Chapter 9: Slope, Survey, Scaling, and Boundary Defects

Section B — Inadequate Site Plan & Partial Boundary Verification (No Stamped Survey of Record)

Figure A1: Poverty Flats Site Plan showing proposed location of cultivation sites in relation to ridge lines and property boundary. Note: None of the cultivation sites are on the top of the ridge lines as claimed in the MND.

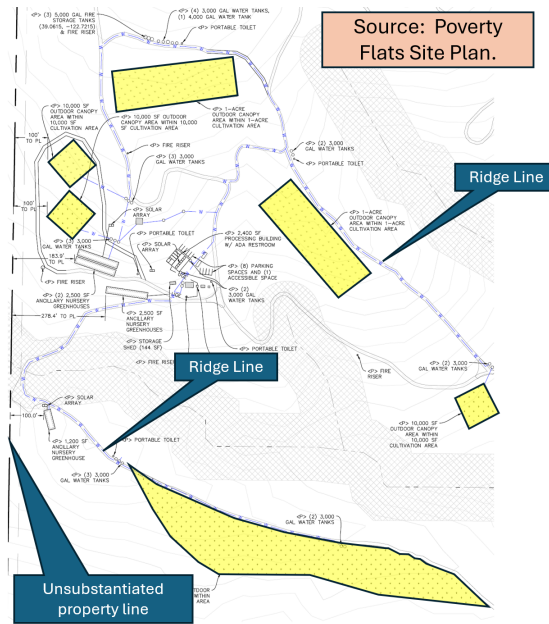
The IS/MND reports an average slope of ~39.5%, and the Property Management Plan describes southern-aspect sloping montane topography—both incompatible with a “flat ridgetop” characterization [A4][A5]. In addition, the site plan locates multiple cultivation pads, access roads, and fencing lines along south- and southwest-facing hillslopes below the ridgeline, with contour spacing that reflects steep grade bands (e.g., 30–50% and greater) rather than level ridgetop benches (Figure A1, A2, A3, A4). Several features would require cut/fill and slope-length breaks to achieve workable grades, which further confirms the on-slope siting. Taken together, the file’s own drawings place project elements on steep slopes, directly contradicting the narrative assertion that cultivation areas are “flat, ridgetop areas” and triggering the need for slope-responsive analysis under CEQA. [A11][A12][A4][A5] [A6]

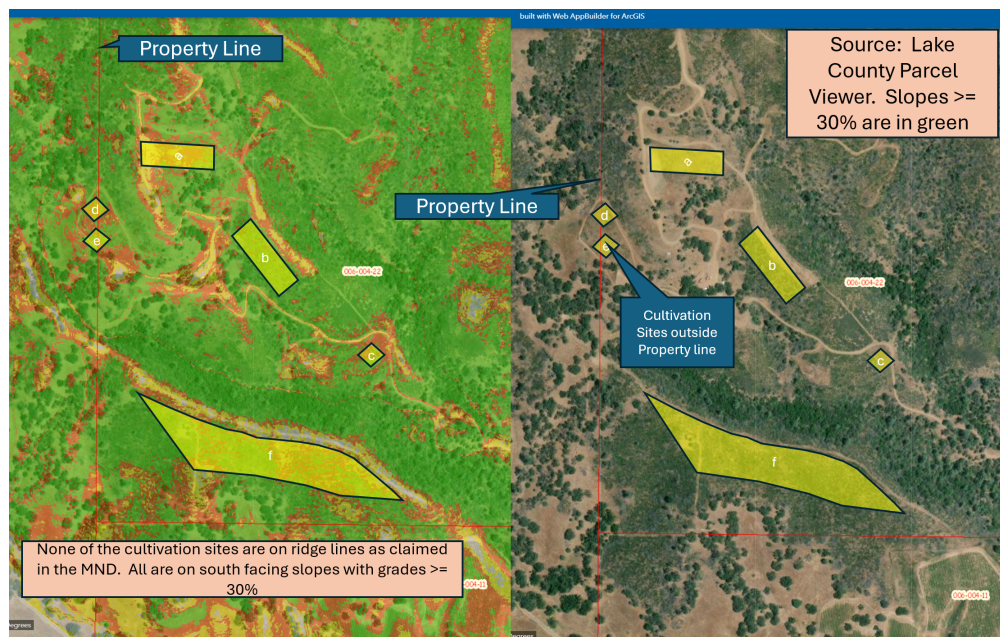
Figure A2: Poverty Flats cultivation sites overlaid onto Lake County Parcel Viewer maps with slope overlay. Note slopes in green are $\geq 30\%$. Note: viewer-based overlay indicates slopes $\geq 30\%$. Viewer alignment suggests Sites “c” and “d” may not be fully inside the parcel; confirmation requires a stamped boundary survey.

Viewer-based overlays indicate areas of close proximity to parcel lines and

potential encroachment for two cultivation sites (Figure A2, A3). Because the western boundary has reportedly been field-verified, uncertainty may be reduced along that edge, but there is no stamped survey of the remaining parcel boundaries or the disturbance polygons. Accordingly, encroachment cannot be confirmed or ruled out without a complete, stamped boundary (and topographic) survey. The County Surveyor has already instructed that Parcel Viewer lines are not acceptable for legal parcel boundaries or setbacks and that a professional survey must control setback measurements. Separately, BLM has required a professional survey to confirm the project's position relative to federal lands. Until a stamped survey demonstrates that each cultivation polygon and associated grading/fencing lies entirely within the legal parcel and outside all required buffers, any "less-than-significant" finding that depends on boundary geometry remains speculative under CEQA.

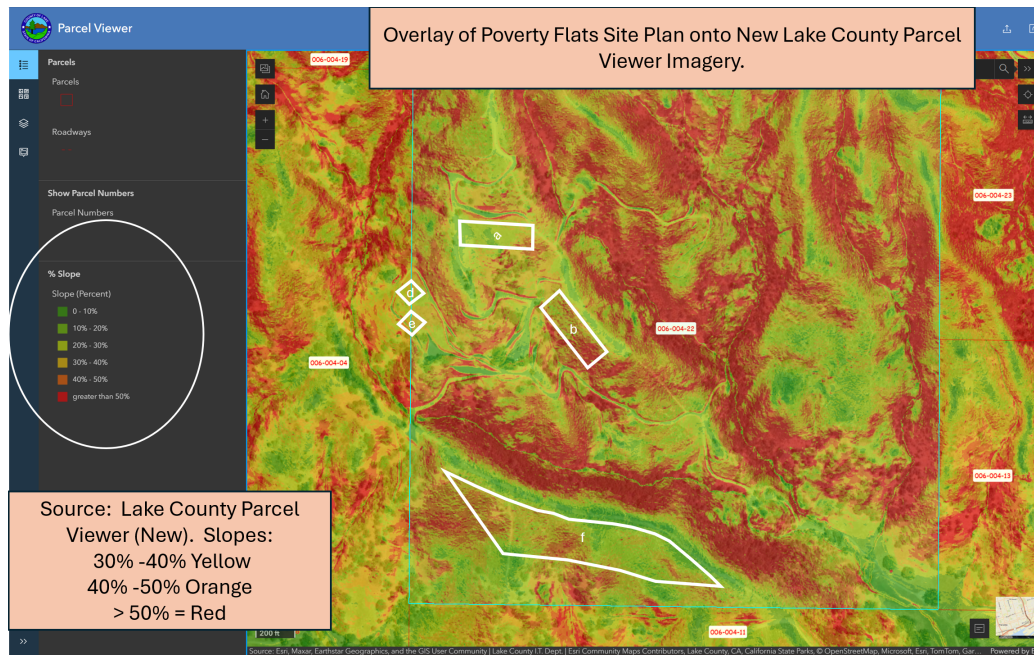
Figure A3: Poverty Flats cultivation sites overlaid onto Newer version of Lake County Parcel Viewer maps with slope overlay providing more detail. Slopes in yellow are 30% to 40%; Orange 40%-50%; Red > 50%. Sites “b” and “f” are intersecting slopes >50% -- not allowed by WCB. Also Sites “b” and “f” intersect $\geq 50\%$ slopes under the viewer-based overlay (not allowed by Water Board Tier-2). Viewer alignment also suggests Sites “c” and “d” may not be fully within the parcel; this cannot be confirmed or ruled out without a stamped boundary survey.

Figure A4: USDA soil map survey of Poverty Flats approximate cultivation locations. Note: All locations exceed 30% grade and are on soils with “high to severe” erosion risk.

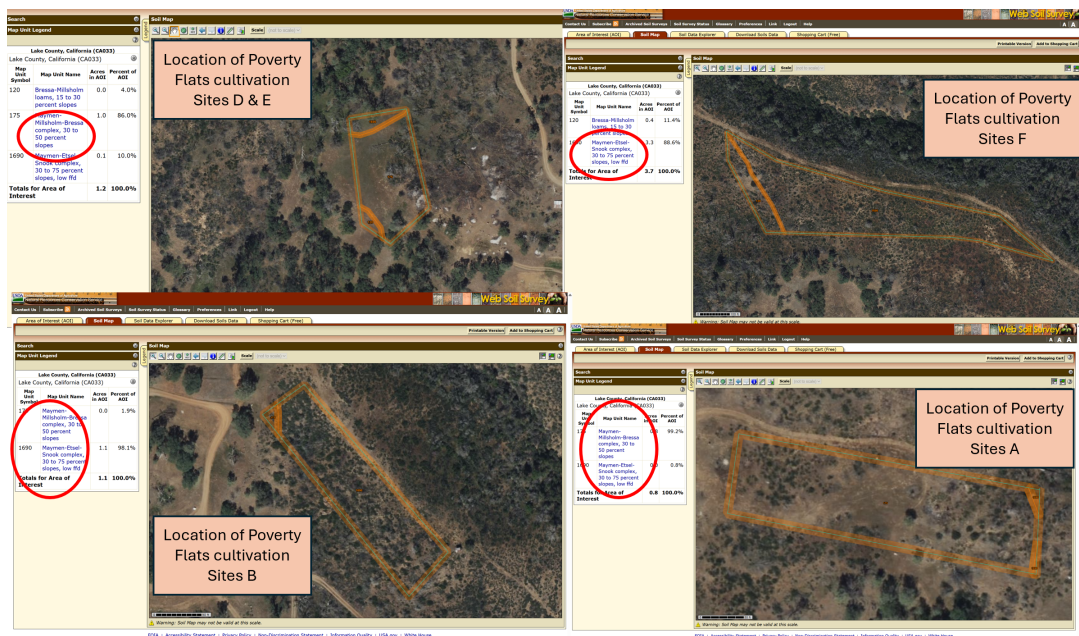
Site-plan overlays and USDA soil mapping place cultivation polygons across 30–50% and 50–75% slopes, on units the Clear Lake Nutrient TMDL identifies as severe erosion hazard (e.g., Maymen–Etsel–Snook 30–75% (severe); Maymen–Millsholm–Bressa 30–50% (severe)), confirming high potential for sediment delivery absent robust controls [A14] (Figure A4).
